Re: **Contract C1800176** – (Aladdin Plating Site Remediation Project, Tacoma, Washington)  
Rejection of Claim-02 Associated with Quantity Overages and Positive Shoring

Re: **Contract C1800176** – (Aladdin Plating Site Remediation Project, Tacoma, Washington)  
Final Offer Change Order 2 (Equitable Adjustment for Quantity Overruns)

**Table 1**  
**Subsurface Excavation Quantities Specified in Project Manual**  
Former Aladdin Plating Site  
Tacoma, Washington

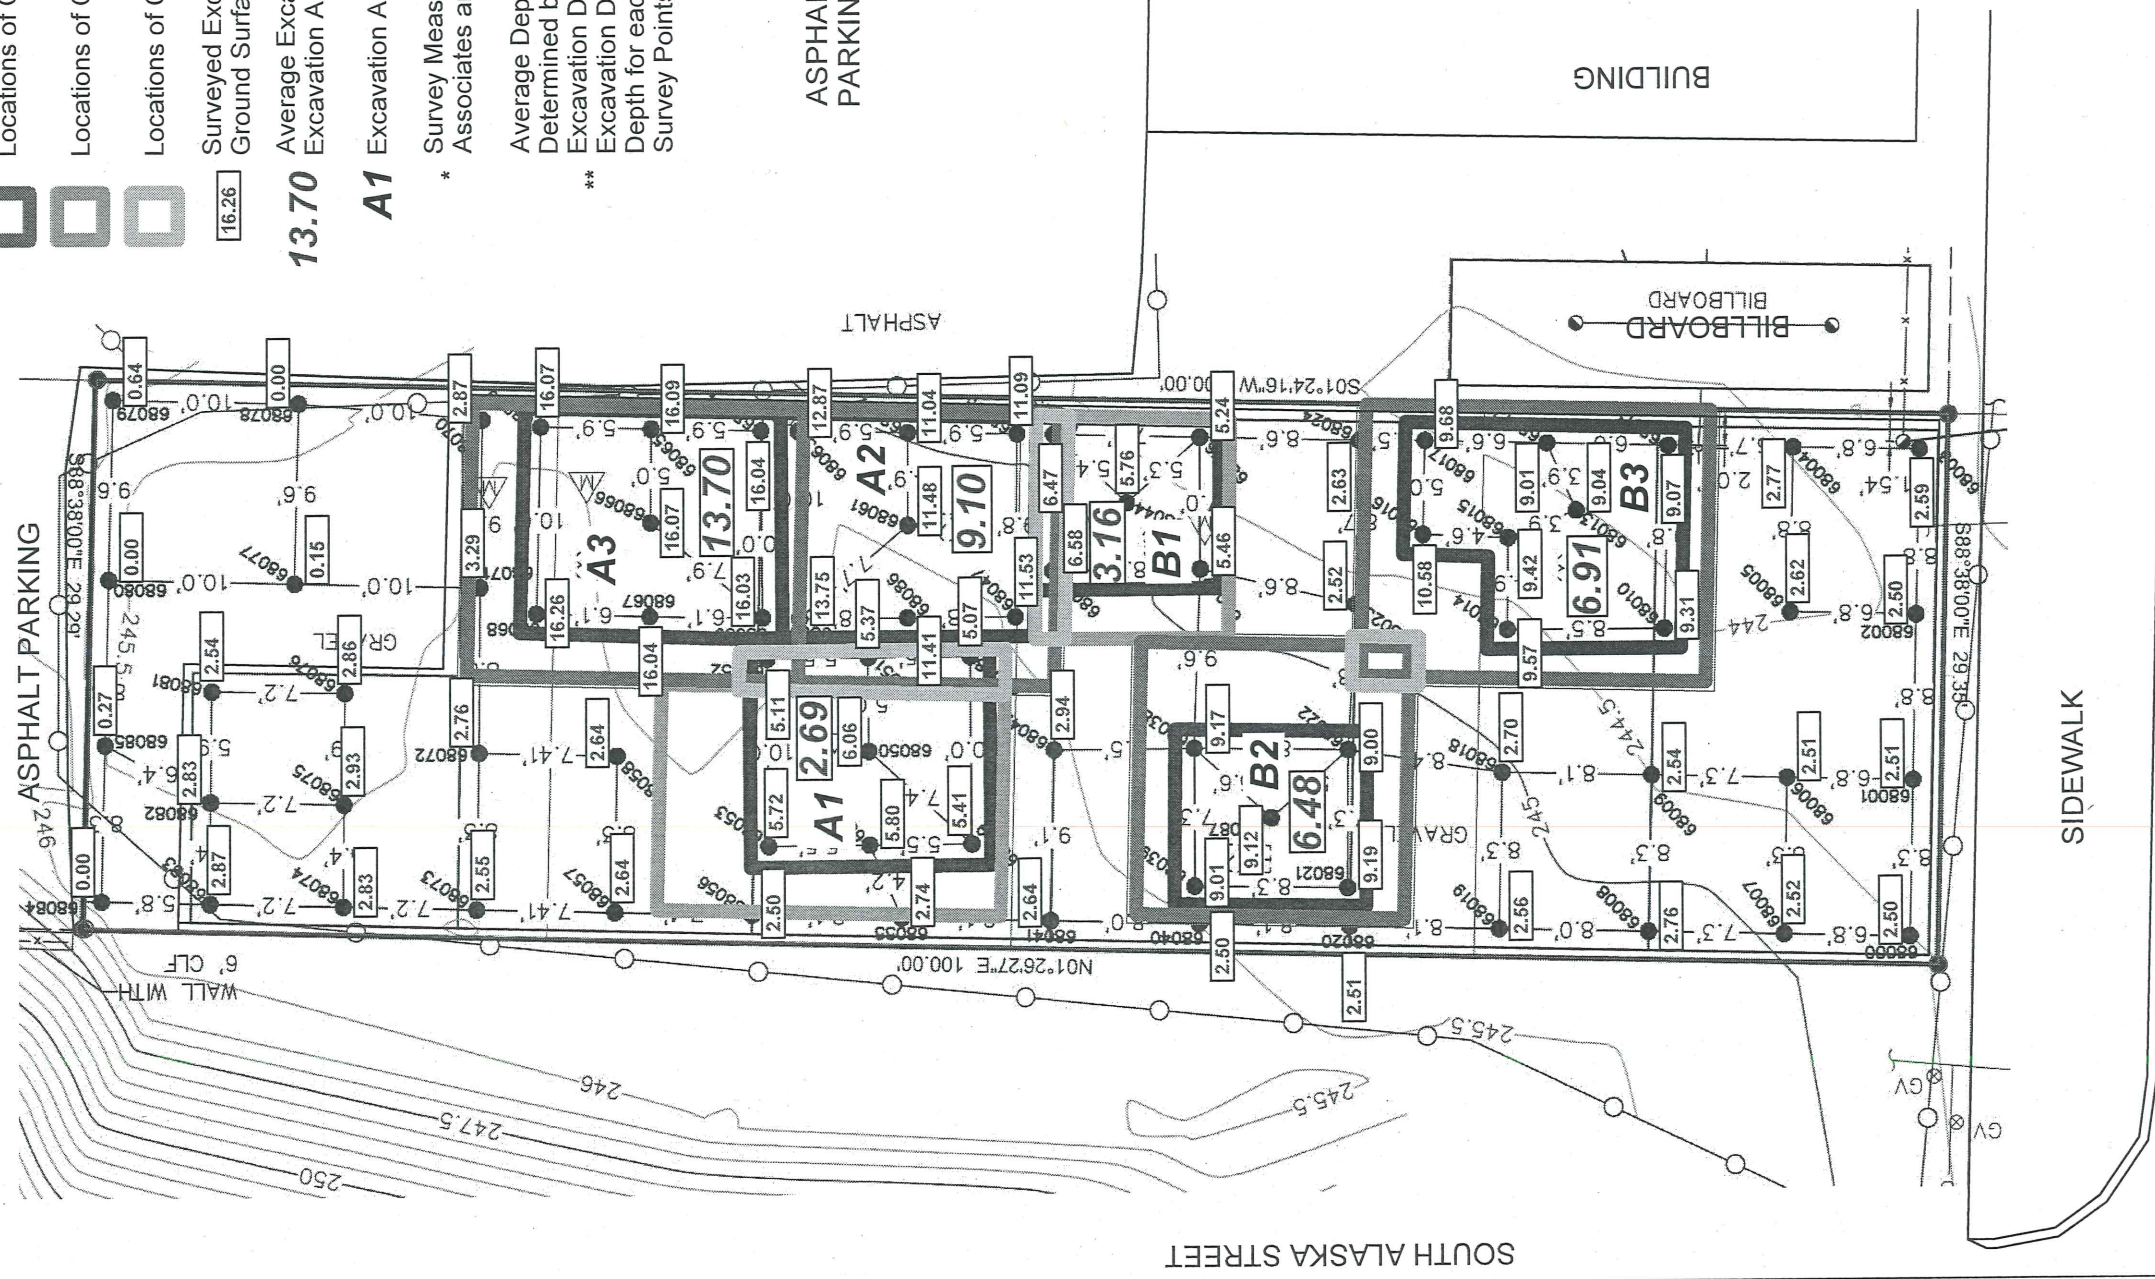
An evaluation was performed to identify the source(s) of soil that contributed to the quantity removed by 3 Kings from the site. The results of the evaluation are presented in enclosed Table 1 and on Figure 1. The evaluation has determined that all but a limited amount of the difference between the quantity specified in the Project Manual (330 tons) and what was disposed of by 3 Kings (620 tons) was due to the actual volume of material removed by 3 Kings as extra excavation for installation of shoring and sloping that 3 Kings elected to use for the project.

As shown in Table 1 and on Figure 1, the extra excavation performed by 3 Kings for sloping and to install the shoring 3 Kings elected to use includes the following:

- Extra excavation consisting of sloping of un-shored excavations at remediation areas A1 and B1.
- Extra excavation resulting from the surface area encompassed by the shoring 3 Kings elected to use for excavation at areas A2, A3, B2 and B3.
- Extra excavation due to 3 Kings methods used to install the shoring used for the project.
- Extra excavation that included re-excavation of soil backfill at areas A1, B1, and B3 as a result of the overlapping surface area encompassed by the shoring 3 Kings elected to use.
- Extra excavation where 3 Kings dug to a depth greater than specified in the Project Manual.

The volume of subsurface soil excavated by 3 Kings that is attributable to the extra excavation described above and presented in Table 1 and on Figure 1 totaled 167 cubic yards. The tonnage of subsurface soil excavated by 3 Kings that is attributable to extra excavation based on the density of soil utilized in the Project Manual (1.5 tons per cubic yard) is 250 tons. The quantity of soil removed by 3 Kings as extra excavation (167 cubic yards/250 tons) was an increase of 76% over the quantity specified in the Project Manual (220 cubic yards/330 tons), not 20% as stated in 3 Kings' CO-2. The costs associated with a 76% increase in the soil quantity attributed

to 3 Kings' extra excavation is included in Pay Item M. Therefore, no additional Contract Sum or Contract Time is warranted for 3 Kings' extra excavation.

Pay Item M also specifies that the contractor shall supply an equal quantity of backfill to replace soil removed as a result of extra excavation. Therefore, no additional Contract Sum or Contract Time is warranted for 3 Kings' for backfilling the areas of extra excavation.
